M2PP-121-D-PLNM-0003

Site Specific Management Plan 003 - [sectors 360/370/380]  
MacKays to Peka Peka Expressway

01 SEPTEMBER 2014 - CERTIFIED ISSUE - REV C

## SITE SPECIFIC MANAGEMENT PLAN - WHAREMAUKU BASIN [SSMP 3 - SECTOR 360, 370, 380]

1. AEE SECTIONAL ELEVATION - WHAREMAUKU STREAM BRIDGE SOUTHERN ABUTMENT - 1:200@A3

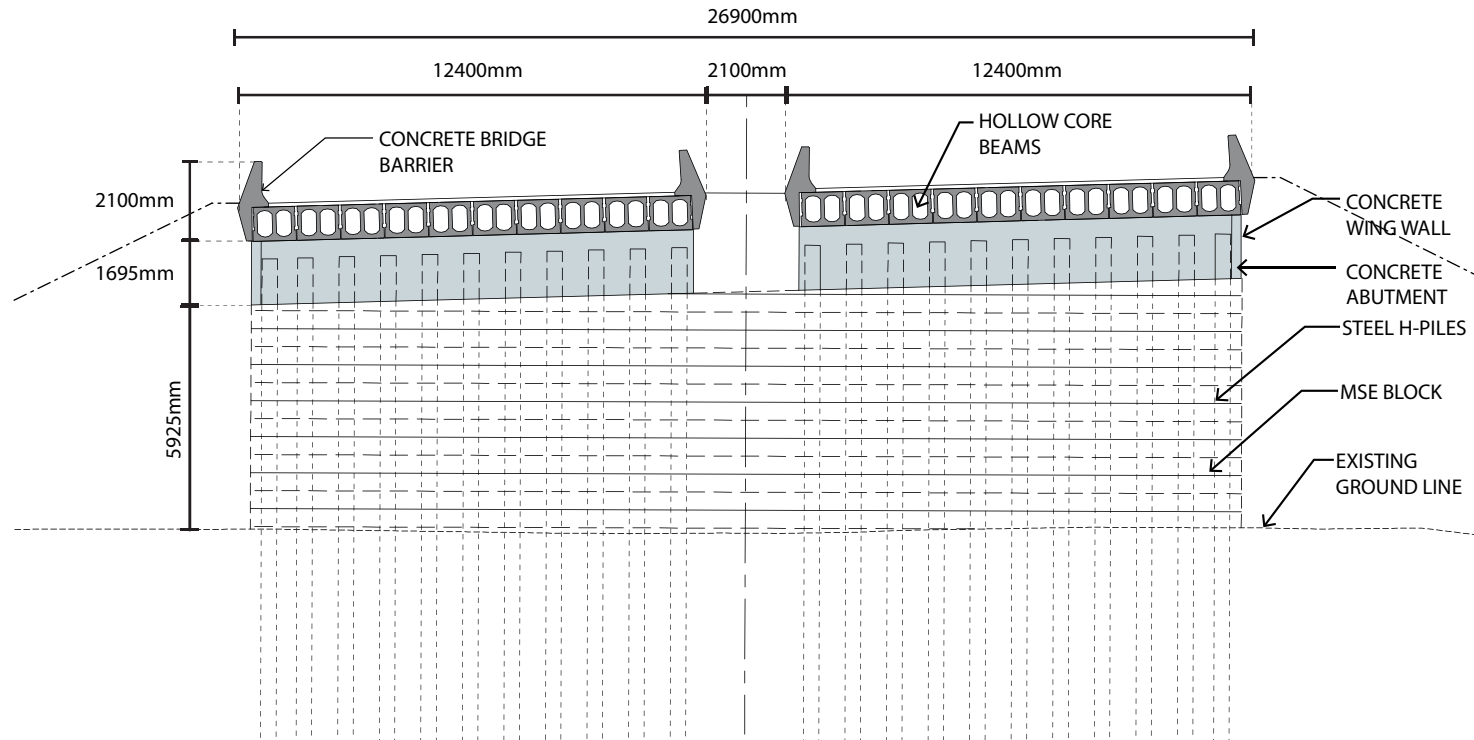
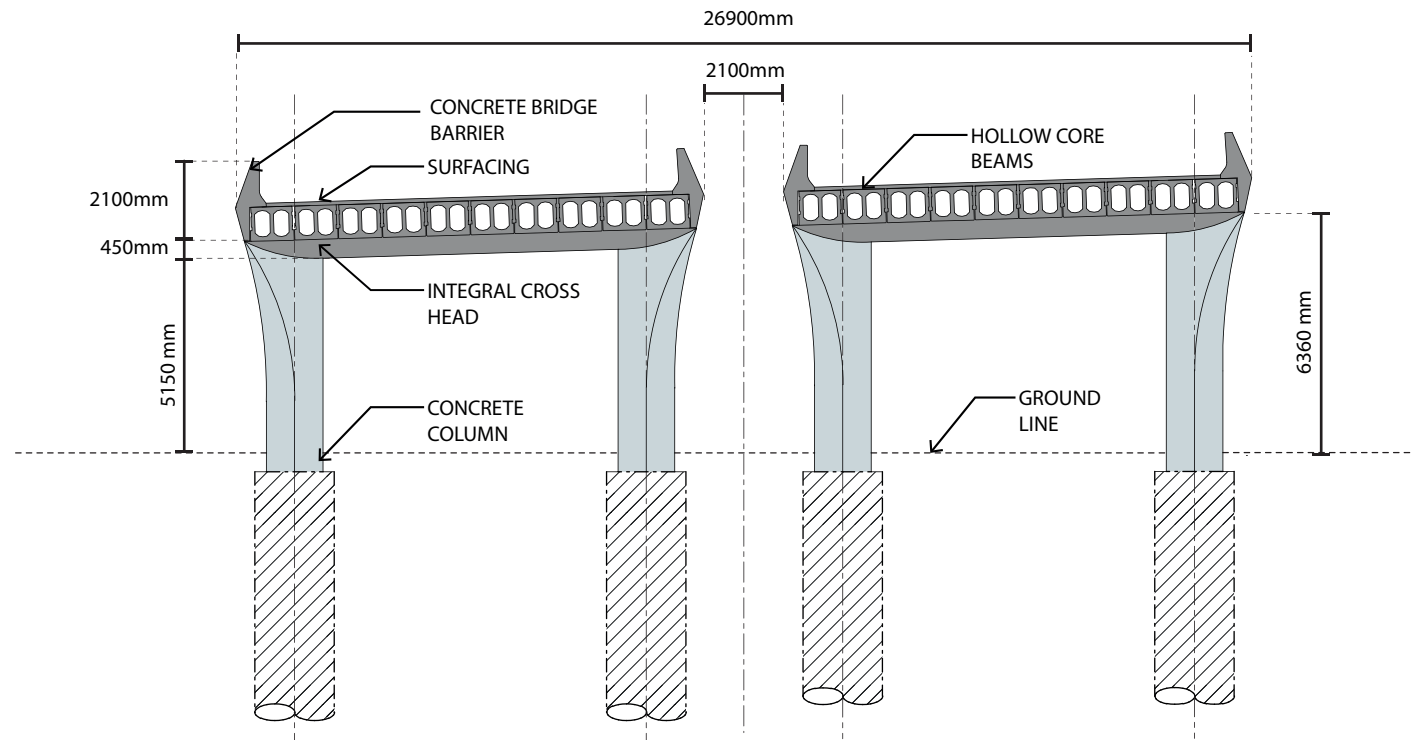
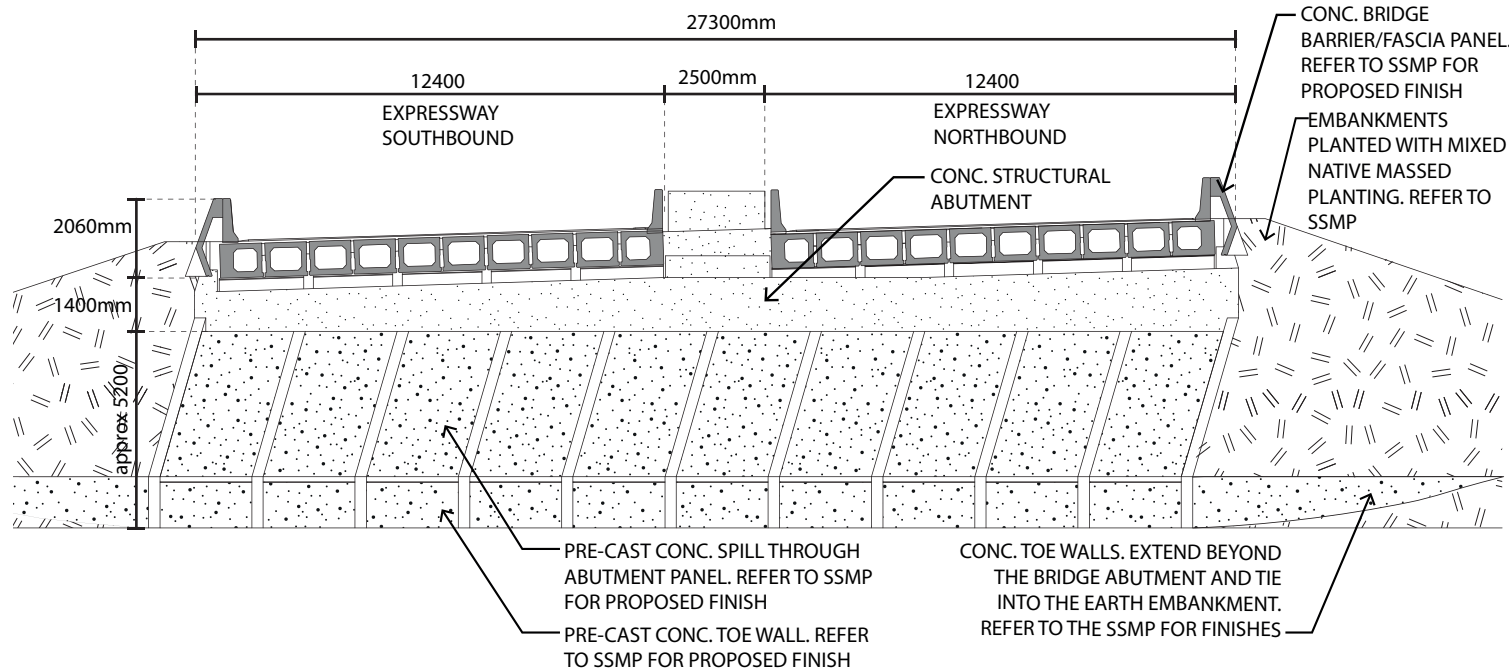
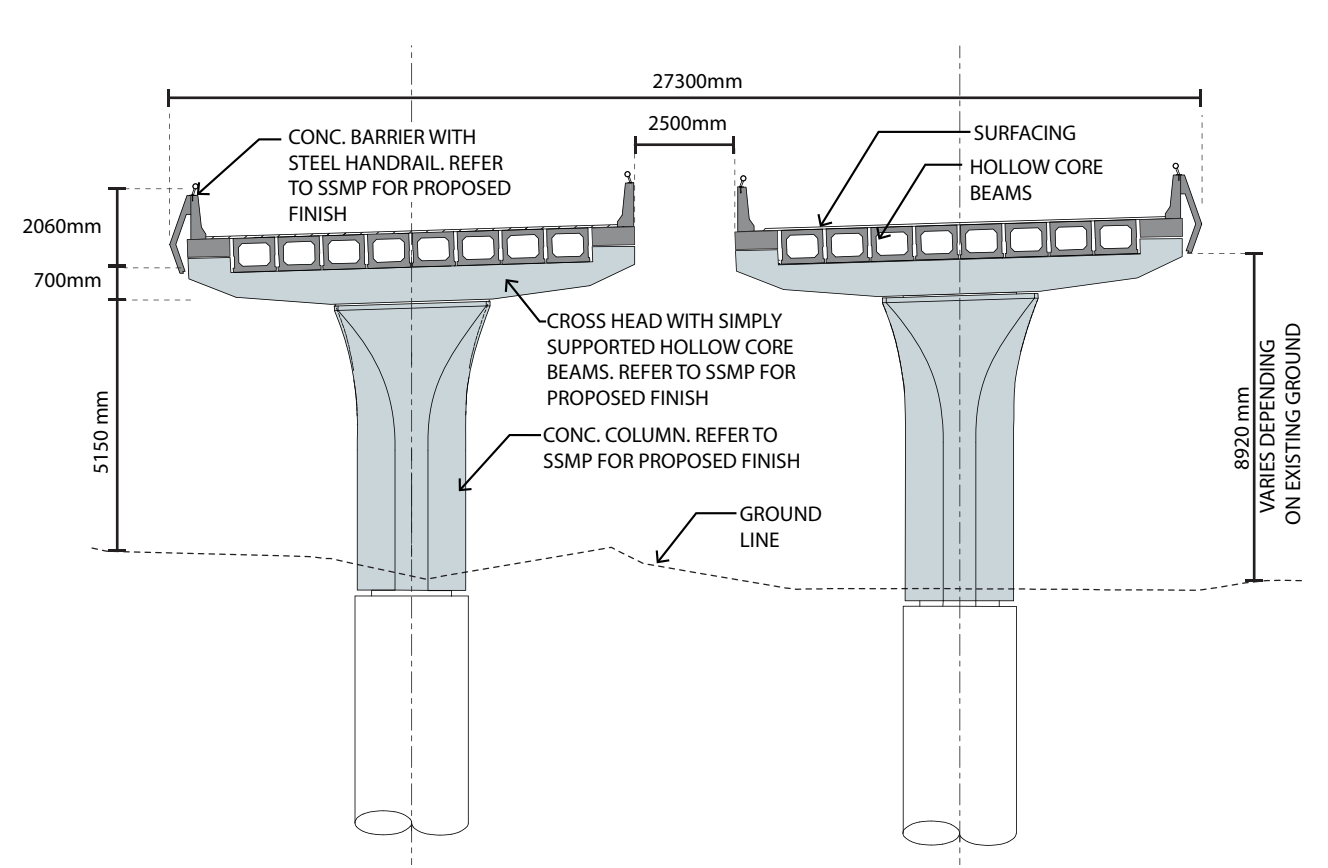
1. Bridge barrier drawn correctly
2. Bridge abutment grade has increased
3. Column profile developed

1. Barrier drawn incorrectly in AEE elevation, Actual barrier depth unchanged from AEE simulations
2. Geotechnical and flood modelling developments since the NOR/AEE submission
3. Increased structural core based on geotech investigations carried out post AEE, while still providing the sculptural outer.

PROPOSED PLAN- KAPITI BRIDGE- 1:500@A3

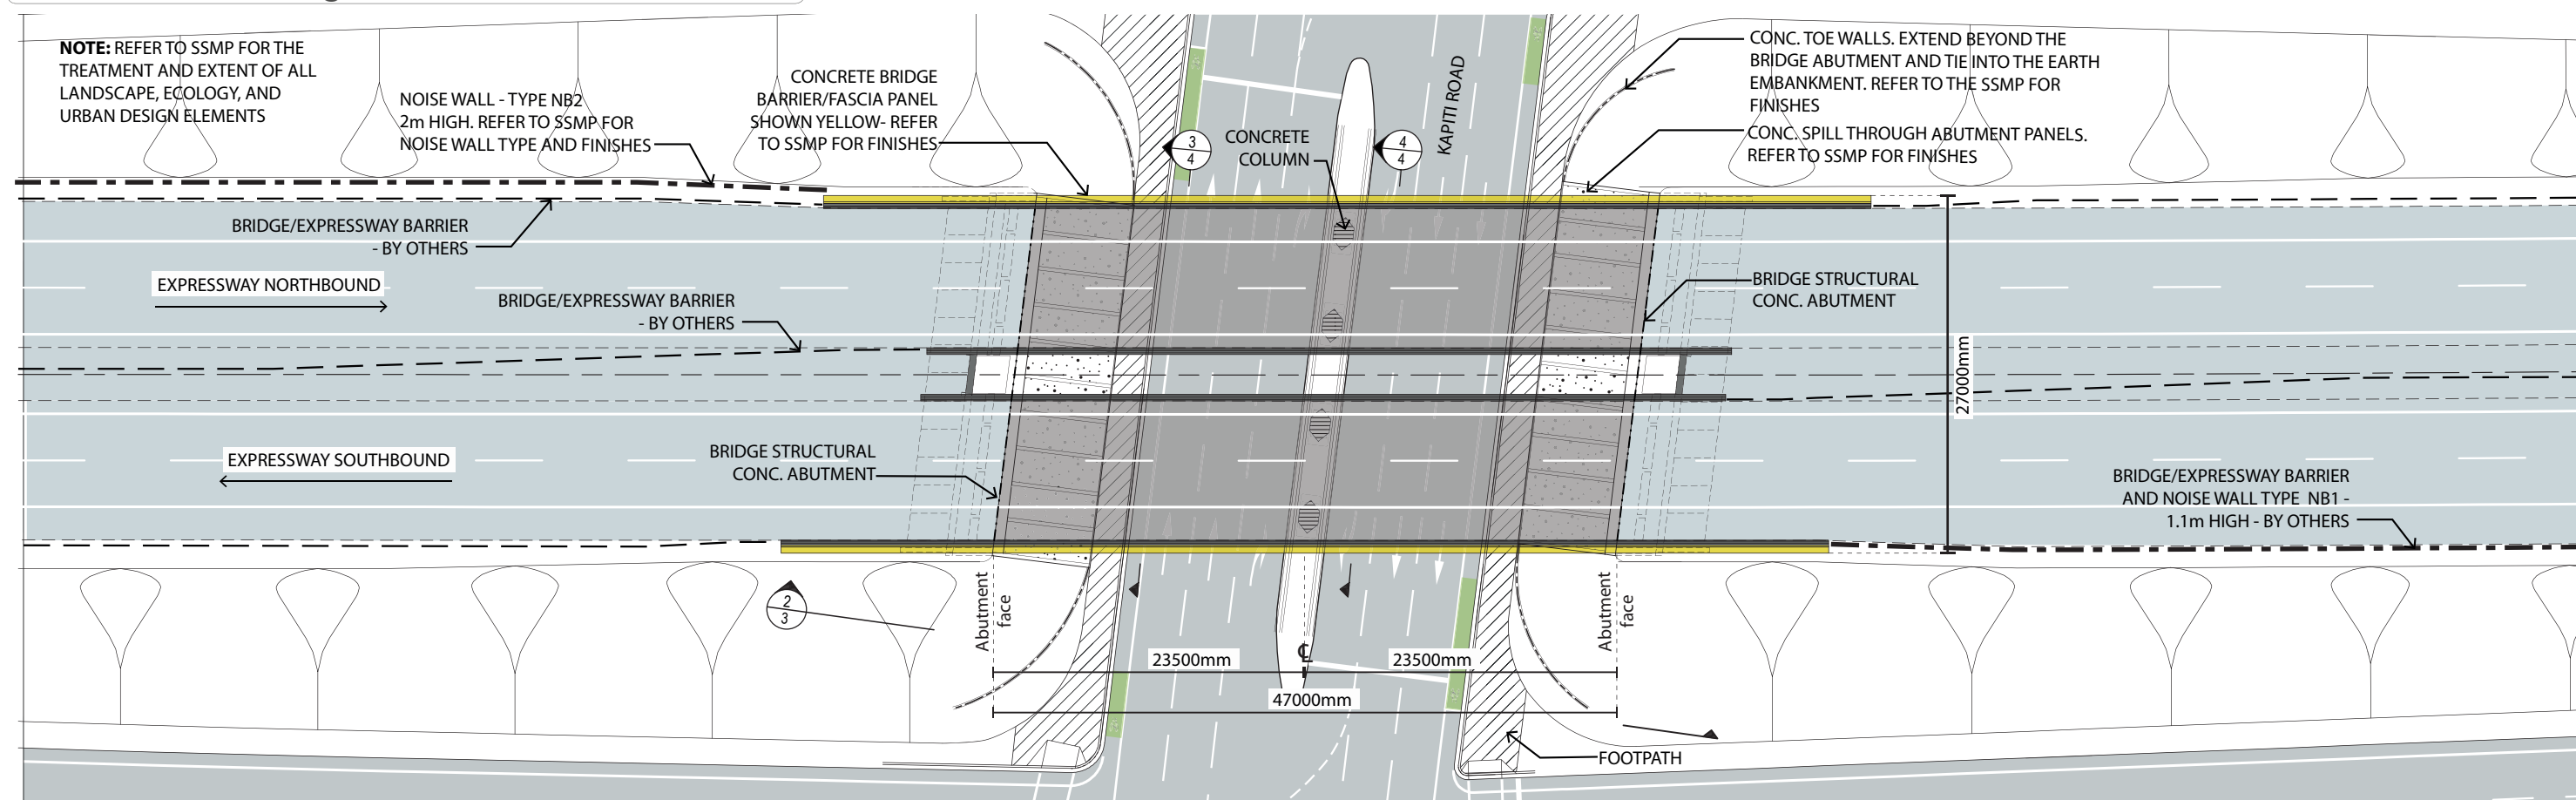
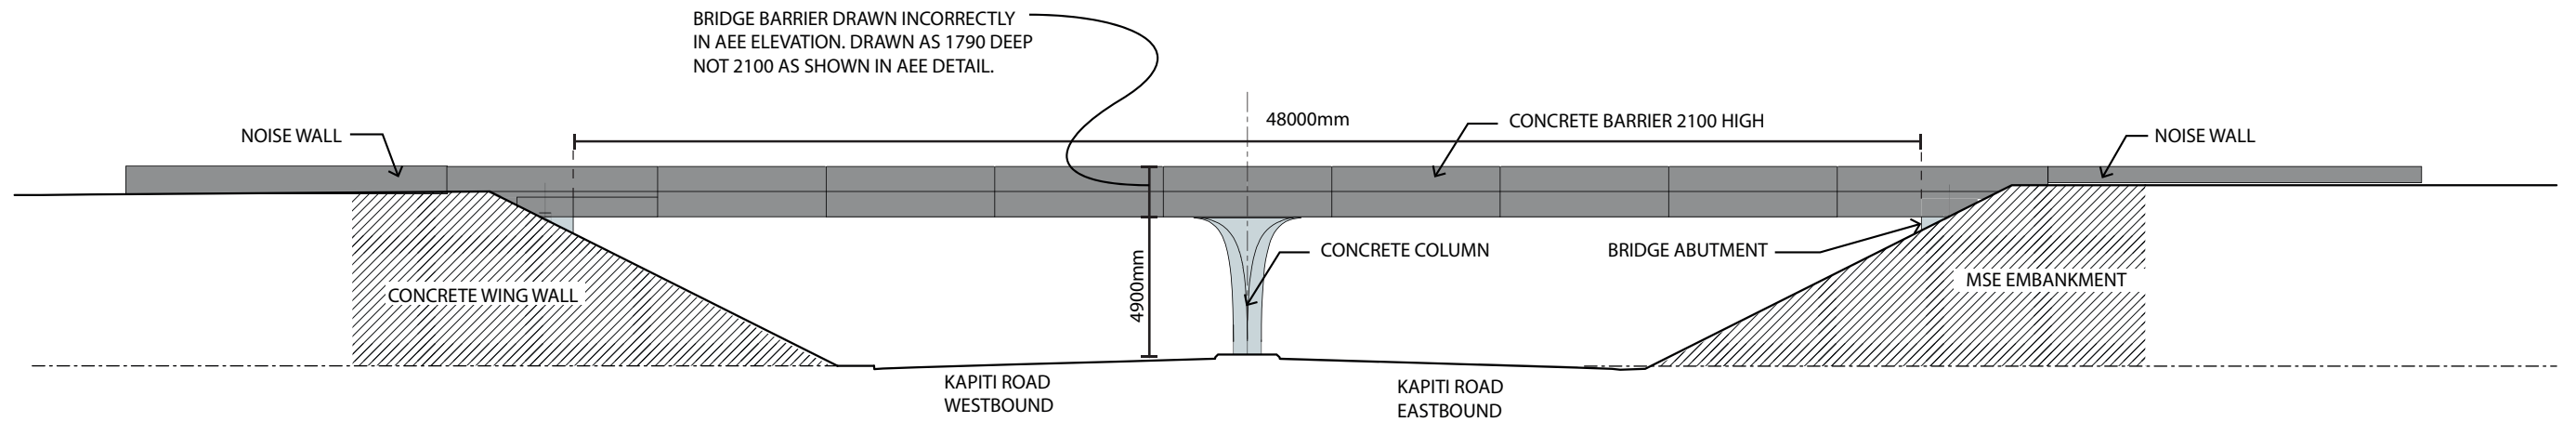
1. Further detail provided for abutment treatment
2. Further detail provided for pedestrian and cycle (treatment)
3. Columns moved in-board

1. AEE SECTIONAL ELEVATION - KAPITI BRIDGE ABUTMENT (LOOKING SOUTH) 1:200@A3

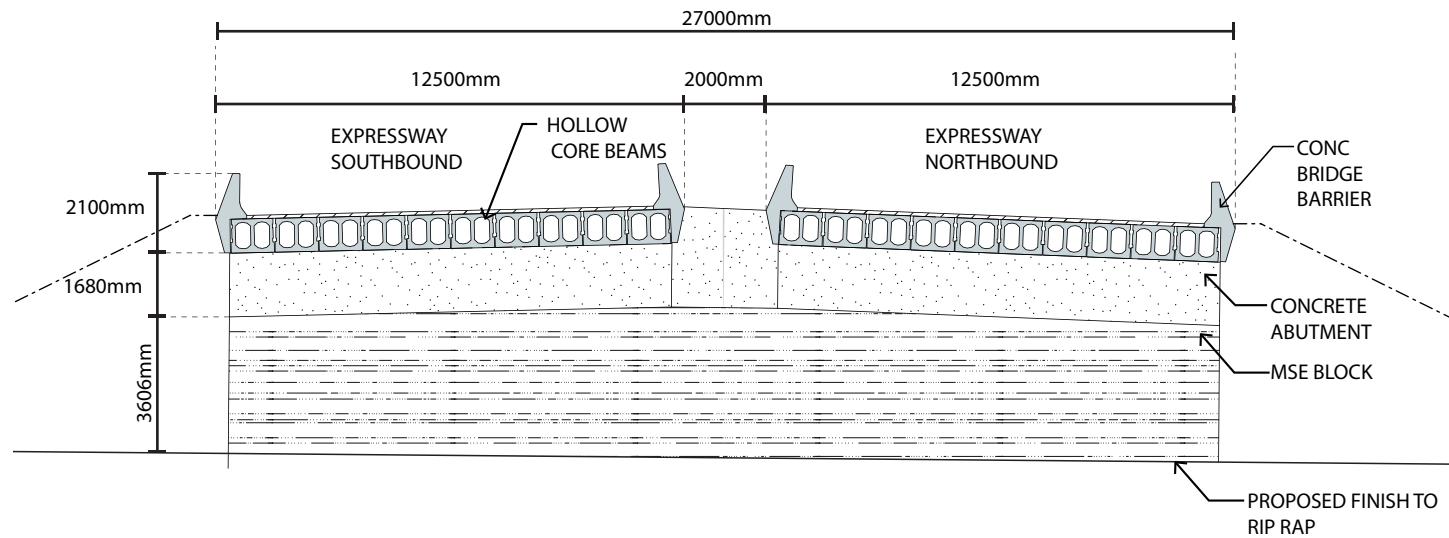
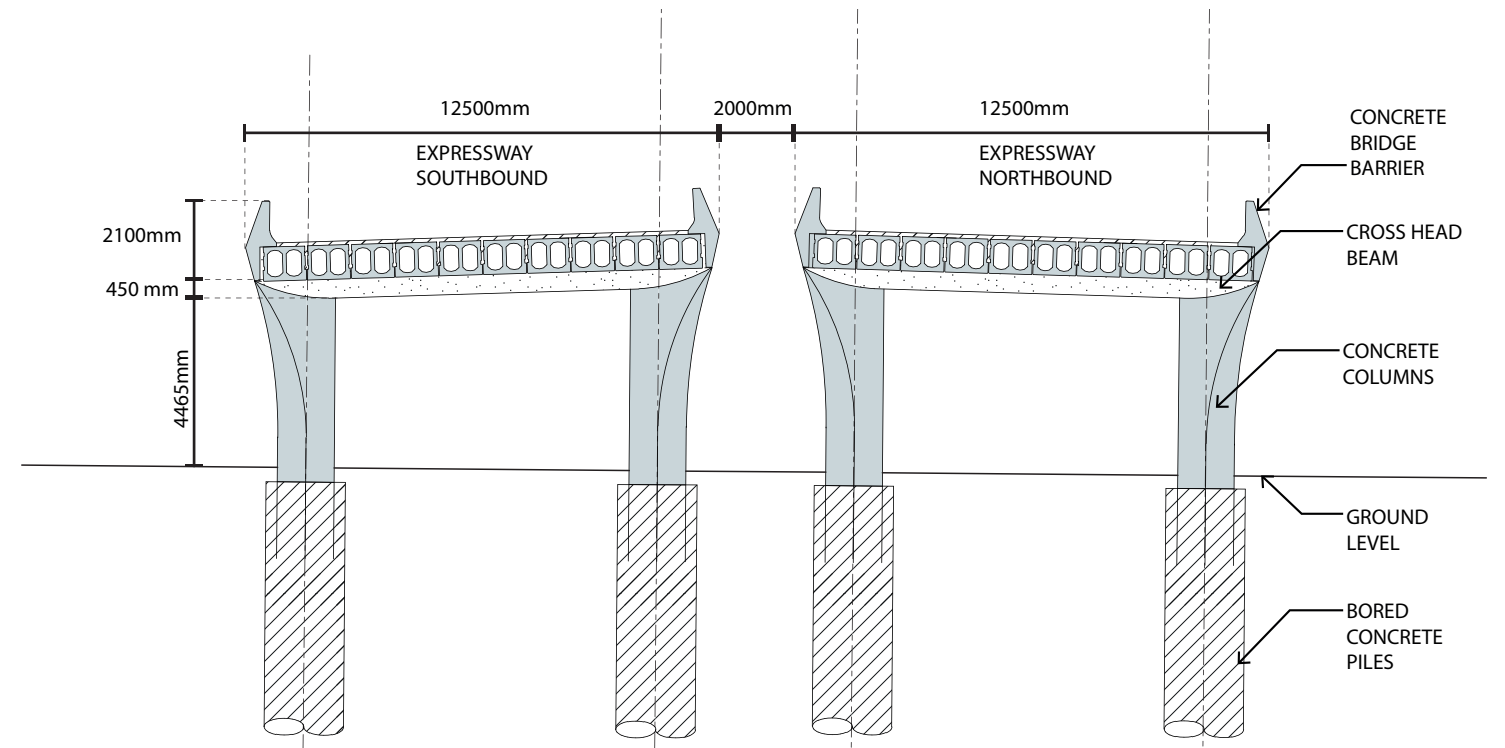
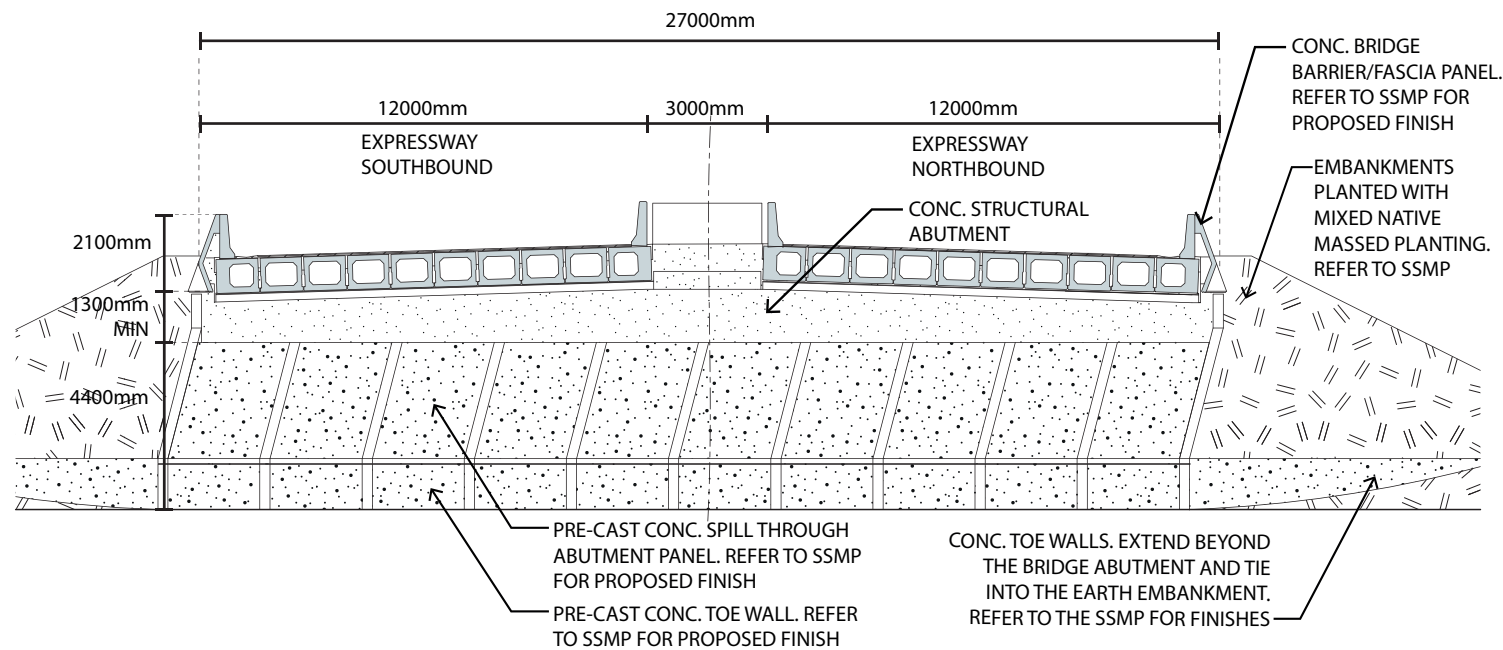
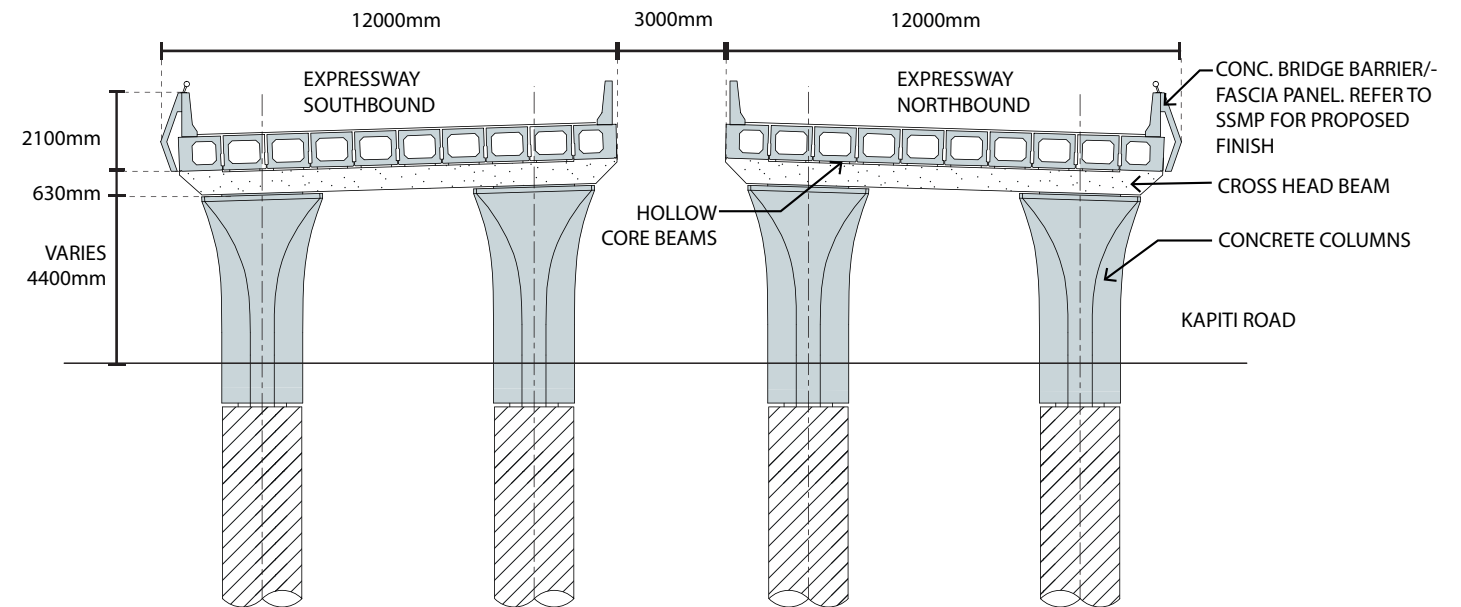
1. Column shape developed
2. Cross head lower by approx 200mm Change to simply supported system. Revised relationship between column, crosshead and barrier

3. Lack of info in AEE. Embankment developed to better integrate the level difference of the embankment and precast conc. spill through abutments.
